Duquesne Light

SUBJECT: Beaver Valley Power Station - Unit No. 2
Docket No. 50-412
Open Item/Question Response

This letter forwards responses to the issues listed below. Duquesne Light Company plans to incorporate the responses to the FSAR questions into FSAR Amendment 7. The following items are attached:

FIGURE 1 BEAVER VALLEY UNIT 2 REACTOR COOLANT SYSTEM HEATUP LIMITATIONS APPLICABLE UP TO 10 EFPY

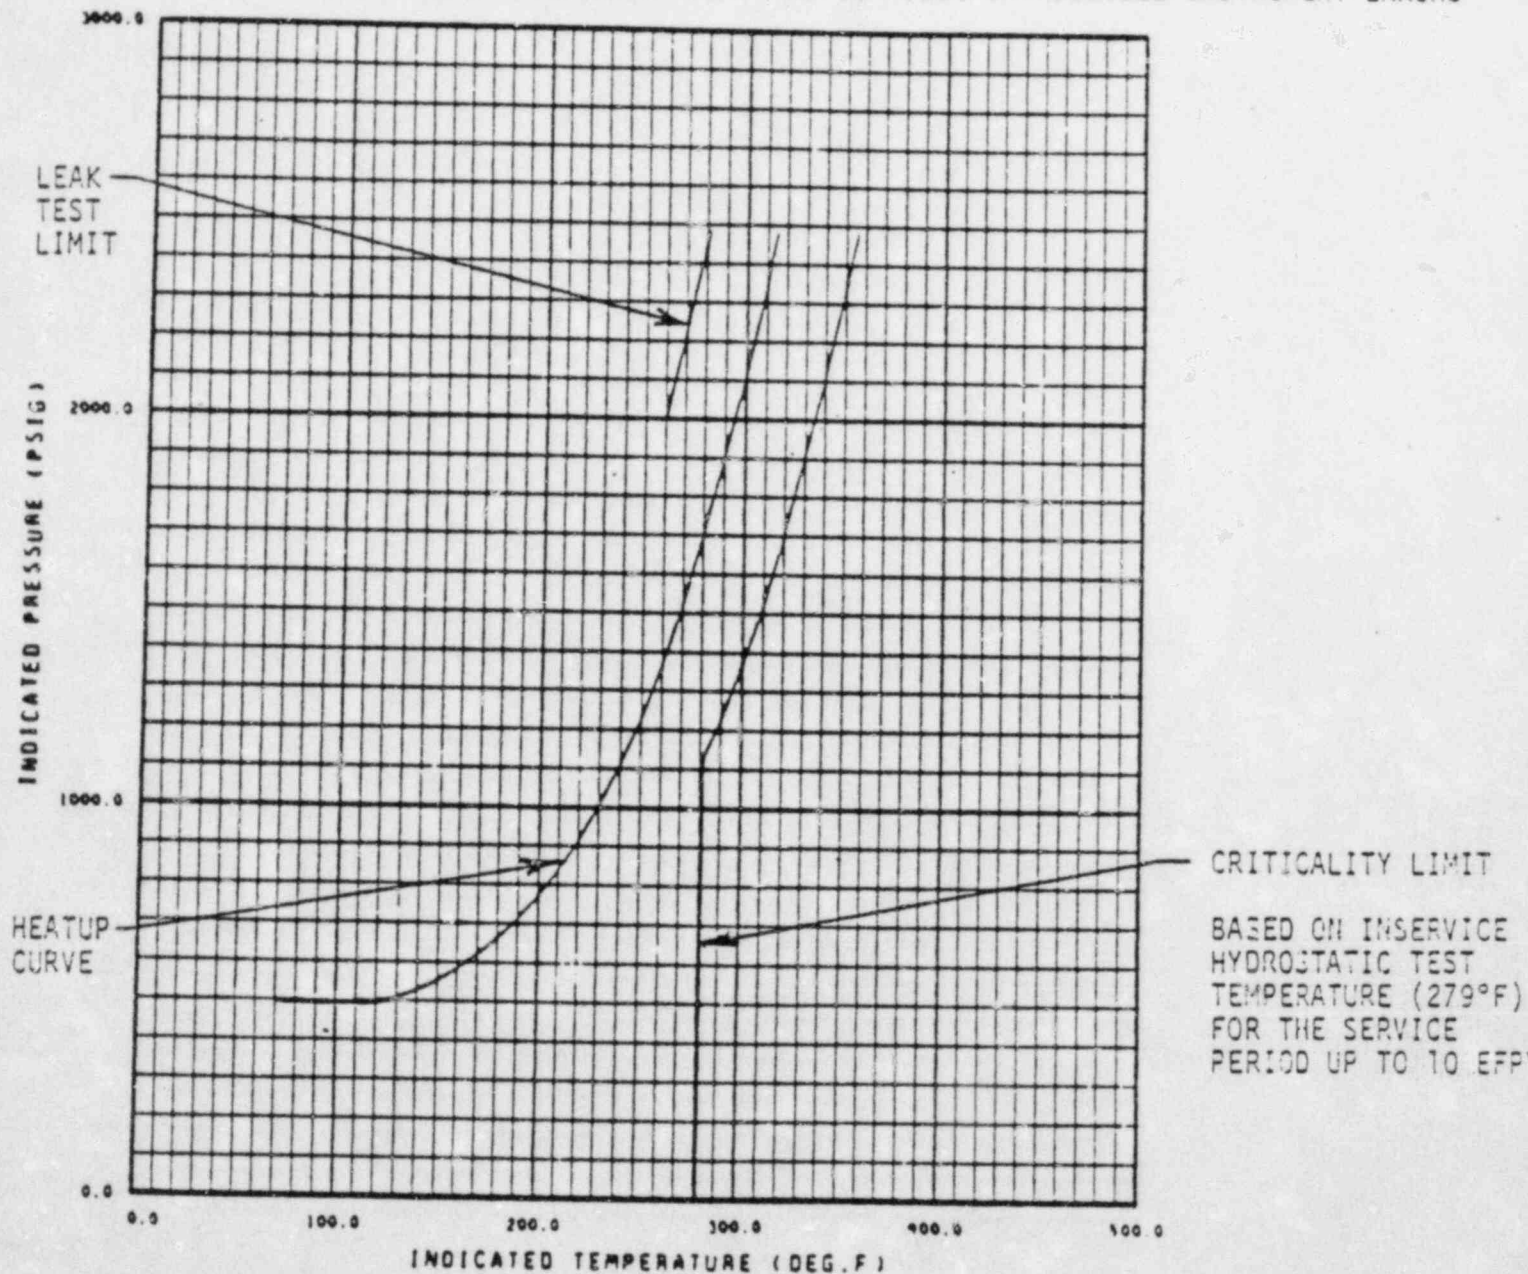
The applicant has not supplied pressure-temperature limit curves for the reactor pressure vessel, which comply with the beltline and closure flange requirements of Appendix G, 10CFR50.

- c. To demonstrate conformance to Appendices G and H, 10 CFR Part 50:
 - (1) Provide pressure temperature limit curves for hydrostatic pressure and leak tests, heat-up, cooldown and core operations.

The pressure temperature limit curves for hydrostatic pressure and leak tests, heatup, cooldown, and core operations is provided in the response to Question 252.1, Item C-1.

- 252.1(C-1) Beaver Valley Unit 2 heatup and cooldown curves are not impacted by the new 10 CFR 50 rule; which addresses the metal temperature of the closure head flange. Specifically, the 10 CFR 50 rule states the minimum metal temperature of the closure head flange should be $RT_{NDT} + 120^{\circ}F$ for pressure above 621 psig which is 20 percent of the preservice hydrotest pressure of 3106 psig. This minimum temperature for the closure head is $110^{\circ}F$ since the RT_{NDT} is $-10^{\circ}F$. As a result, the closure head flange region is less limiting than the heatup and cooldown curves which are based on the beltline region. The original heatup limitations (Figure 1) and cooldown limitations (Figure 2) curves still apply for the Beaver Valley Unit 2 reactor.

Figure 3: Predicted Decrease in Shell Energy as a Function of Copper Content and Fluence.

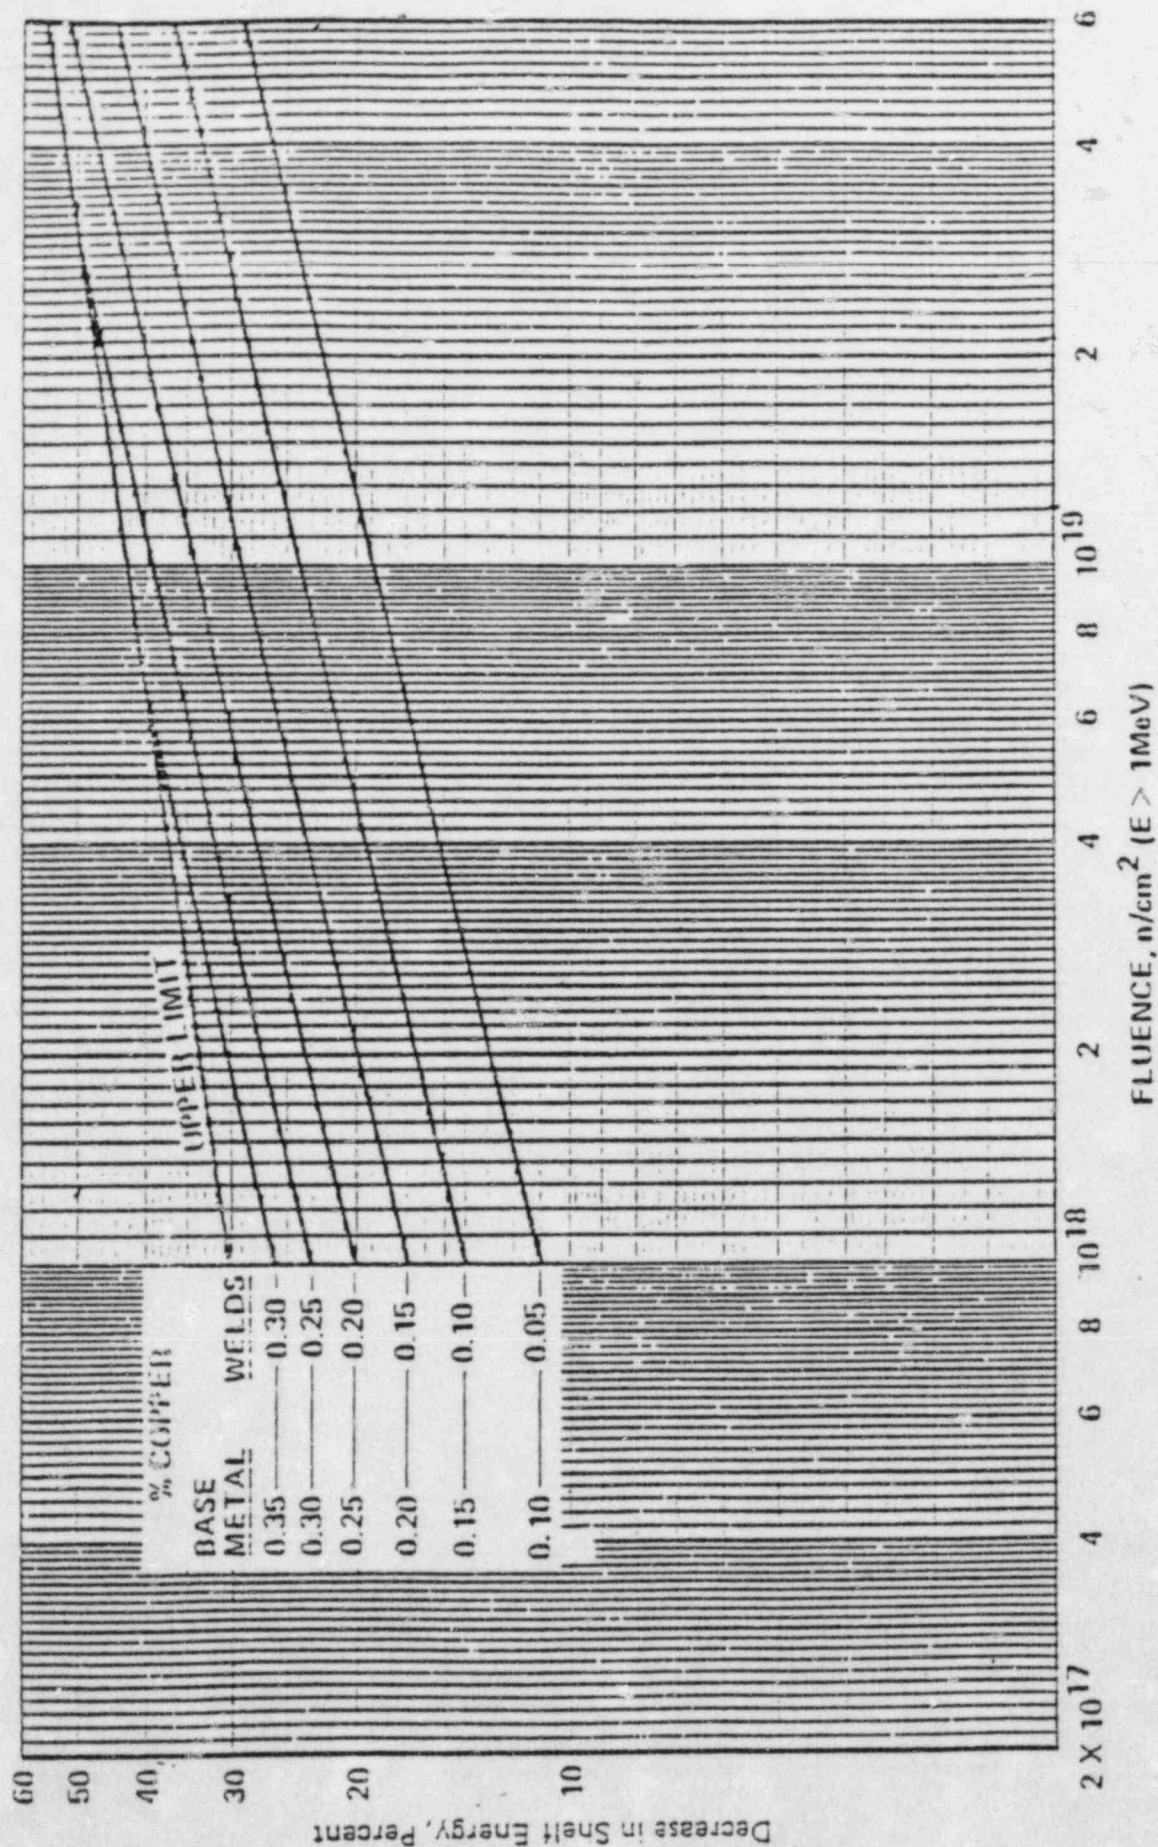
- (4) Indicate the chemical composition (copper, nickel and phosphorus), unirradiated upper-shelf energy, and projected end-of-life RT_{NDT} and upper-shelf energy for all beltline materials. RT_{NDT} projections are to be estimated using the "Guthrie Formula" in Commission Report SECY-82-465. Upper-shelf energy projects are to be estimated using Regulatory Guide 1.99, Rev. 1. These projects are to be for the end-of-life neutron fluence at the 1/4T and ID reactor vessel locations.

252.1(C-4) Chemical compositions for all beltline material is listed in Table 3. Unirradiated upper shelf energy (U.S.E.), projected end-of-life USE's and projected end-of-life. RT_{NDT} are indicated in Tables 4 and 5. RT_{NDT} projections were estimated using the "Guthrie Formula" from Commission Report SECY-82-465. EOL upper shelf energy predictions were estimated using Regulatory Guide 1.99, Revision 1 (Figure 3). Although projections for both 1/4T (Table 5) and ID reactor vessel locations (Table 4) were calculated, the ID location is more limiting due to the higher fluence level.

** - Δ Upper shelf energy was determined from the Regulatory Guide 1.99 method (Attached Figure 3.)
